Ref: 15263.190712.L1

15263: 50 CROWN STREET, READING – ADDENDUM LETTER TO 15263.NIA.01

Figure 1. Indication of the only two windows facing the rear of the building and the location of the extraction duct.

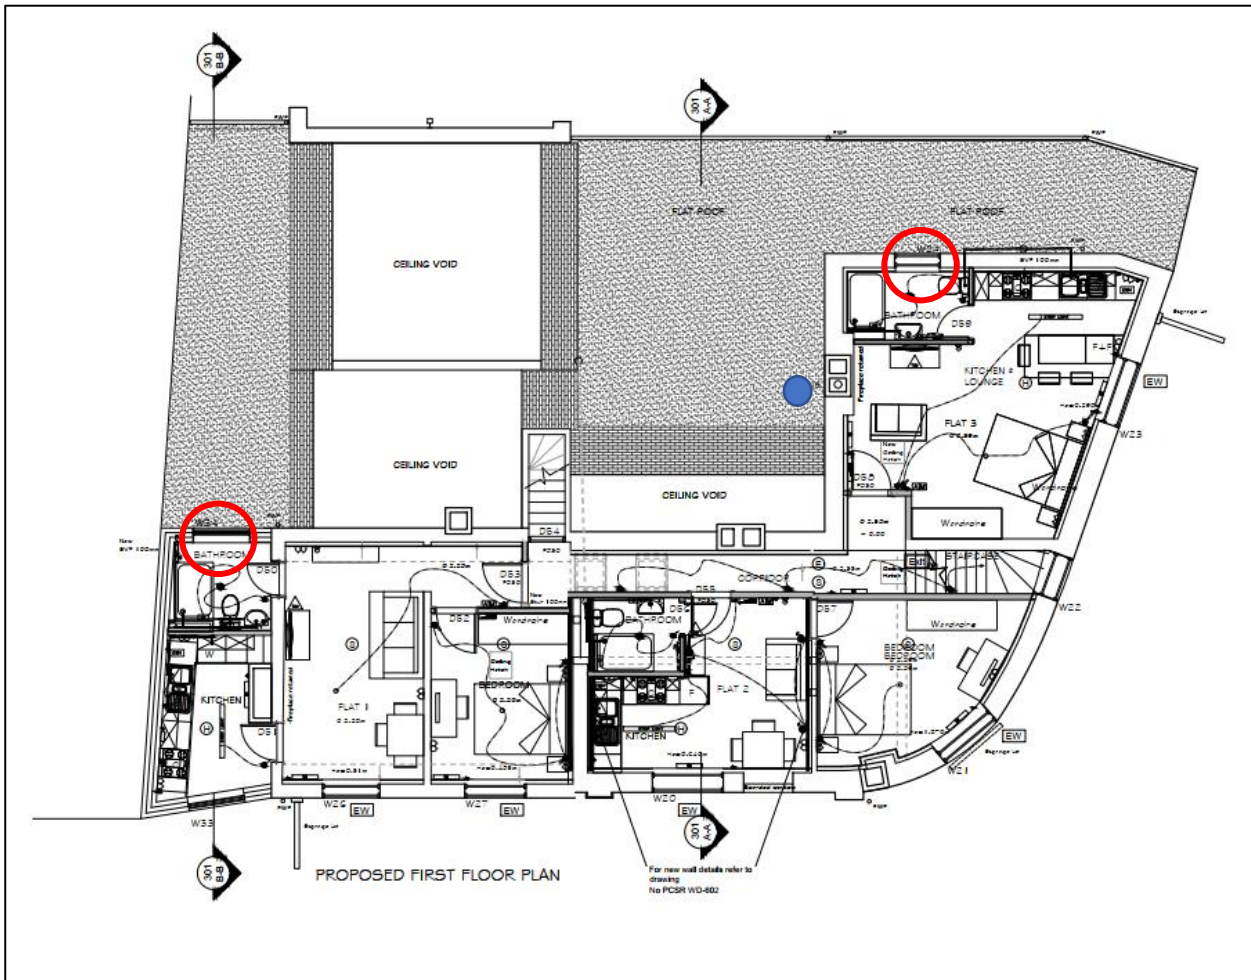
“Concerns are raised that the noise assessment has not considered the impact on the nearest occupiers, namely the future occupiers at first floor level of the application site. It is advised that the assessment is updated to take into account the first floor occupiers. I am advised that it may be that the windows are sufficient to protect from external noise ingress, given they have been designed to attenuate traffic noise. However, you will need to consider whether there will be any internal noise transfer/structure-borne noise impact as well. This is likely to be in the form of an addendum to the existing noise assessment.”

It would be important to mention that the only two windows of the 50 Crown Street building facing the rear belong to bathrooms as shown in Figure 1. Noise impact assessment standard procedures take into consideration those areas that are considered ‘habitable spaces’. These are bedrooms or living rooms, and in some cases kitchens. Hence, these windows would not be considered noise sensitive receivers in the Noise Impact Assessment issued for planning.
